The Commission has issued the enclosed Amendment Nos. 49, 49 and 46 for License Nos. DPR-38, DPR-47 and DPR-55, for the Oconee Nuclear Station, Unit Nos. 1, 2 and 3. These amendments consist of changes to the station's common Technical Specifications in response to your request dated October 26, 1977.

These amendments revise the Technical Specifications to allow operation of Oconee Unit 1, Cycle 4 with a quadrant flux tilt in excess of 3.41%, provided power is restricted to 75% rated power for operation with flux tilt in excess of 3.41% and provided that flux tilt does not exceed 6.03%.

Amendment No. 49
License No. DPR-38

SAFETY EVALUATION BY THE OFFICE OF NUCLEAR REACTOR REGULATION

FIGURE 3.5.2-6A1

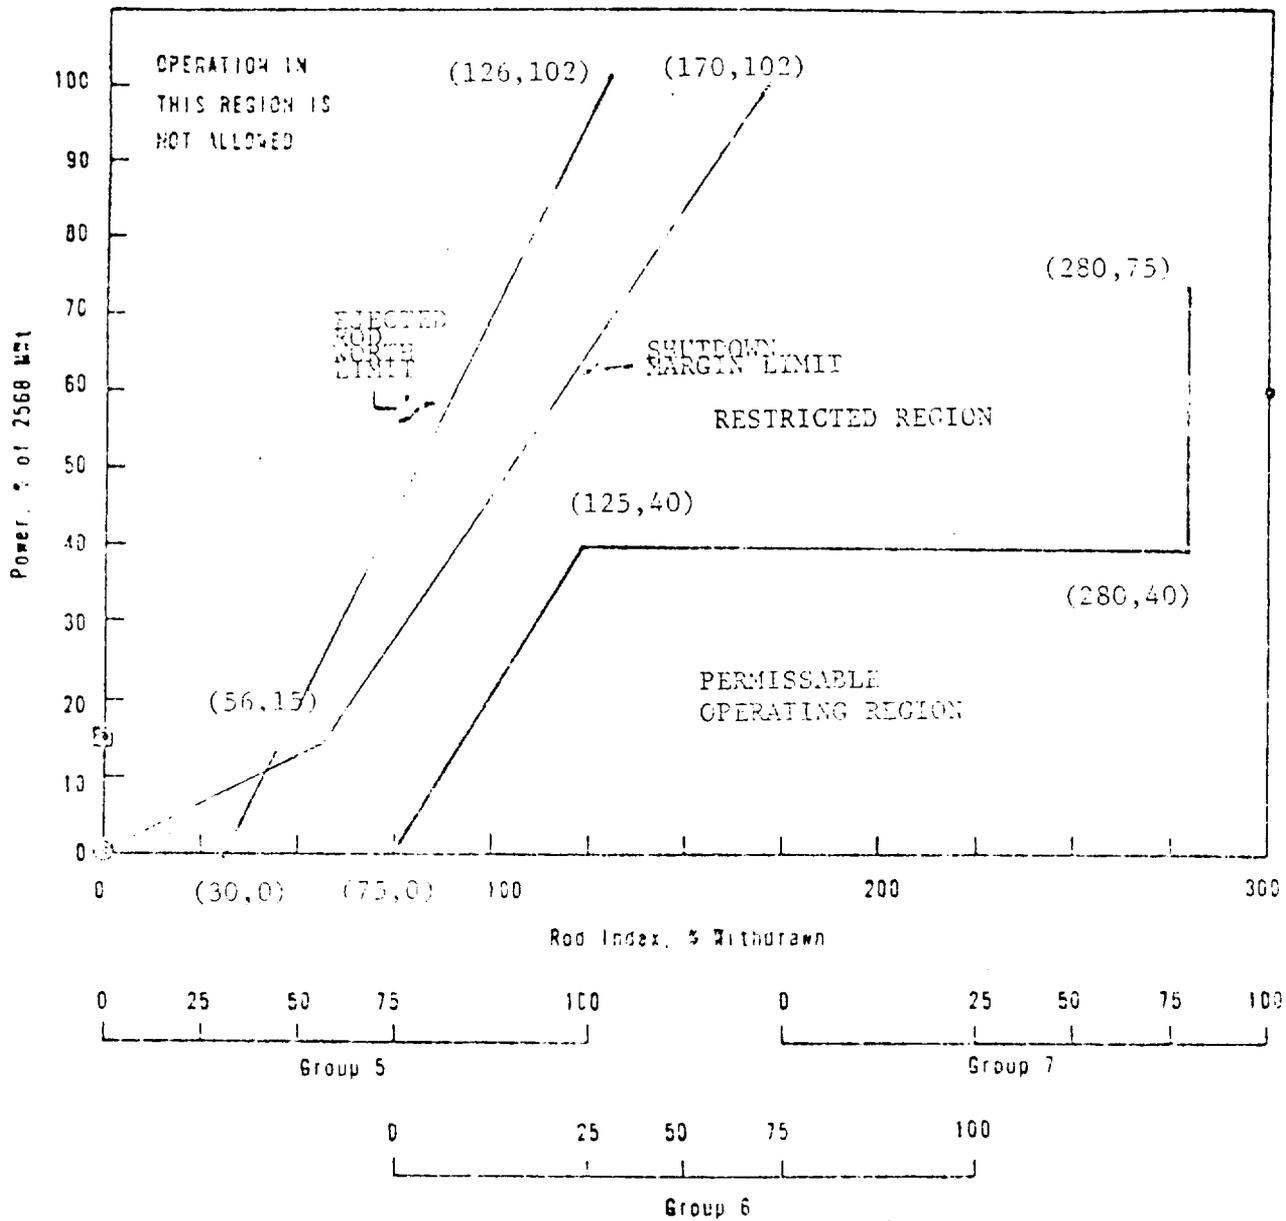
- a. The core thermal power shall be limited to 75 percent full power.
- b. The nuclear power maximum setpoint shall be 84 percent full power.
- c. The quadrant tilt shall not exceed 6.03 percent.
- d. The regulating control rod insertion/withdrawal limits are specified on Figure 3.5.2-6A1

The rod position limits are based on the most limiting of the following criteria: Emergency core cooling system (ECCS) power peaking, shutdown margin, and potential ejected rod worth. The proposed rod position limits are more conservative than those currently in the Oconee Unit 1 Technical Specifications. The licensee has stated that based on maintaining the current power imbalance Specification 3.5.2.6 with the 75% power restriction and the proposed rod position limits, the maximum cladding temperature in the event of a LOCA will not exceed the Final Acceptance Criteria. These proposed rod position limits also ensure the shutdown margin and ejected rod worth criteria are met. The measured and predicted hot zero power values of rod worths were compared and the most restrictive value was used to determine the proposed rod insertion limits. Based on these considerations the proposed rod position limit is acceptable.

ROD POSITION LIMITS FOR
FOUR-PUMP OPERATION FROM 0
TO 100 (± 10) EFPD, UNIT 1
OCONEE NUCLEAR STATION
